VIRGINIA DEPARTMENT OF ENVIRONMENTAL QUALITY
Blue Ridge Regional Office

INTRA-AGENCY MEMORANDUM

Permit Writer	Berkeley			
Memo To	Air Permit File	Date	April 16, 2015	
Facility Name	Virginia Electric & Power Company – Altavista Power Station			
Registration Number	30859 CEDS 24			
County-Plant I.D.	031-00156			
Decimal Coordinates	37.11830	Latitude	-79.27470	Longitude
Elevation (feet)	600			
Distance to Class I Areas	109	SNP (km)	51	JRF (km)
FLM Notification (Y/N)	NA ¹	Required if less than 10K (minor), 100K (state major)		
NET Classification (A, SM, B)	A	Before permit action	No change	After permit action
Title V Major Pollutants	NO _x & CO	Before permit action	No change	After permit action
PSD Major Source (Y/N)	Y	Before permit action	No change	After permit action
PSD Major Pollutants	NO _x & CO	Before permit action	No change	After permit action

Attachment A: Sketch - Monitor locations

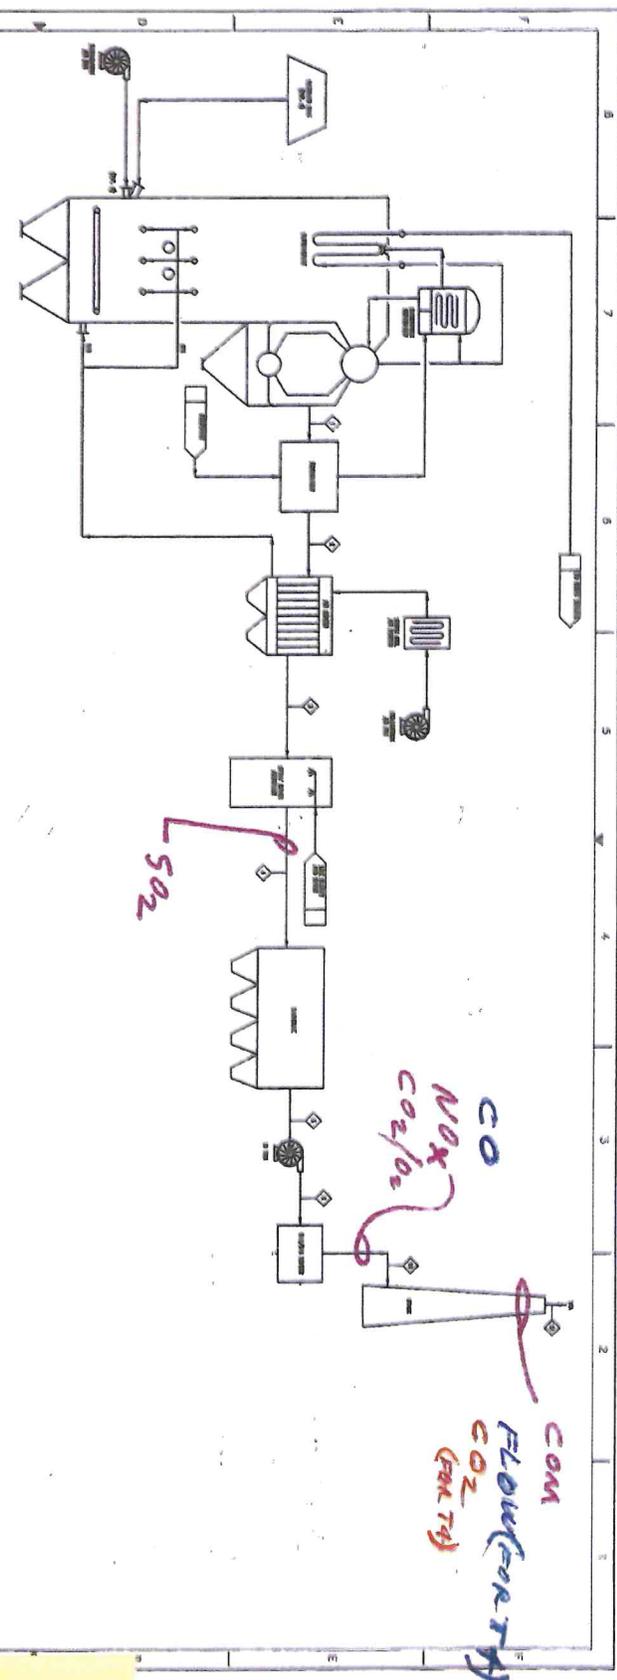
6d. Revise language of 2012 C37 to clarify locations of various CEMS.

Attachment A to this analysis is a sketch that shows locations as provided in the 6/20/14 letter as well as:

- the location of flow monitor (installed for Title IV purposes),
- the CO₂ monitor (installed for Title IV purposes¹⁶), and
- the per boiler CO monitors.

The first comment was a correction to the previously submitted location description for the SO₂ CEMS as shown in Conditions 31 and 77. The 2/13/15 comments included a revised CEM location "sketch."

As part of their response dated 6/20/14 to the ILOD, APS provided suggested language that would satisfy their request for clarity. The provided language was accepted as submitted.
